Form 3160-5 (June 2019)	UNITED STATES DEPARTMENT OF THE INTERIOR BUREAU OF LAND MANAGEMENT	FORM APPROVED OMB No. 1004-0137 Expires: October 31, 2021
SUNDRY NOTICES AND REPORTS ON WELLS <i>Do not use this form for proposals to drill or to re-enter an abandoned well. Use Form 3160-3 (APD) for such proposals.</i>		5. Lease Serial No. NMNM28881
		6. If Indian, Allottee or Tribe Name

Jupiter 30 Fed Com 710H API #: 30-025-52719

EOG respectfully requests an amendment to our approved APD for this well to reflect the following changes:

Revised Permit Information 03/04/2024:

Revised Wellbore

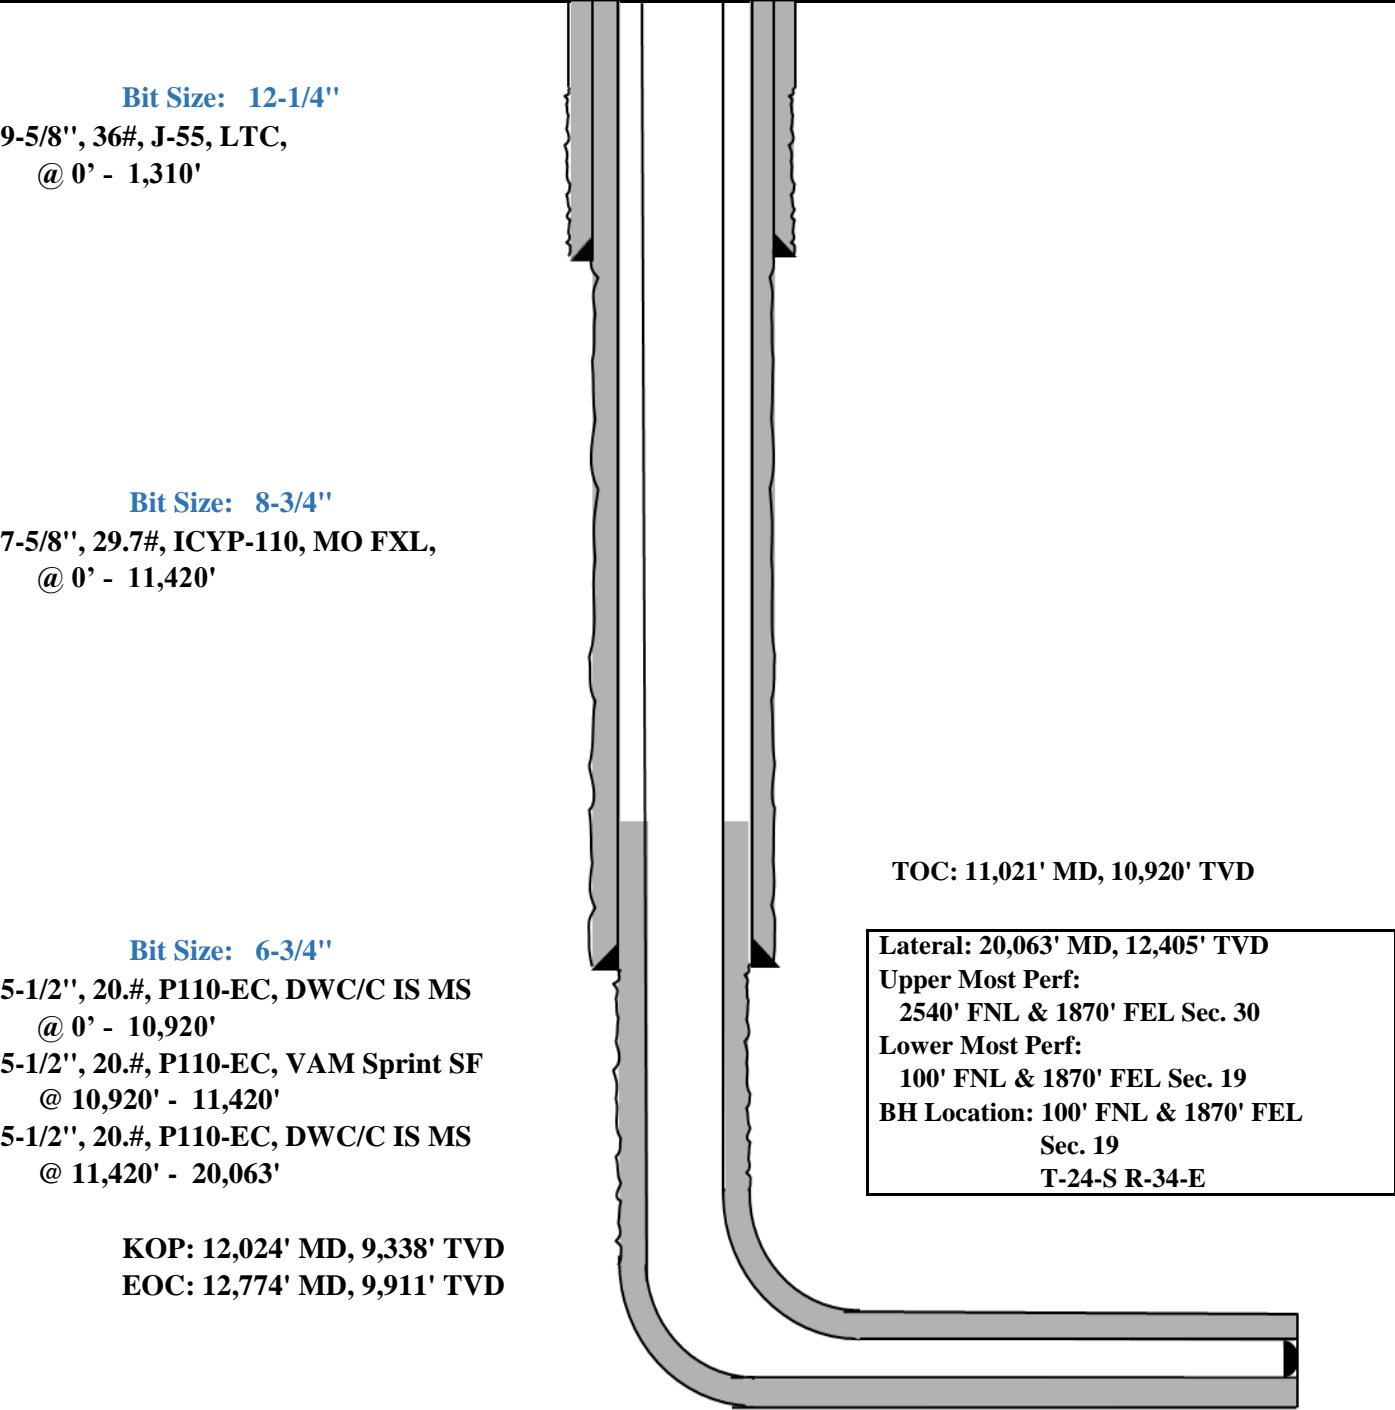
Change BHL from T-24-S, R-34-E, Sec 19, 100' FNL, 2310' FEL, Lea Co., NM,
to T-24-S, R-34-E, Sec 19, 100' FNL, 1870' FEL, Lea Co., N.M.

Update casing and cement program to current design.

Location: SHL: 2310' FSL & 894' FEL, Section 30, T-24-S, R-34-E, Lea Co., N.M.

BHL: 100' FNL & 1870' FEL, Section 19, T-24-S, R-34-E, Lea Co., N.M.
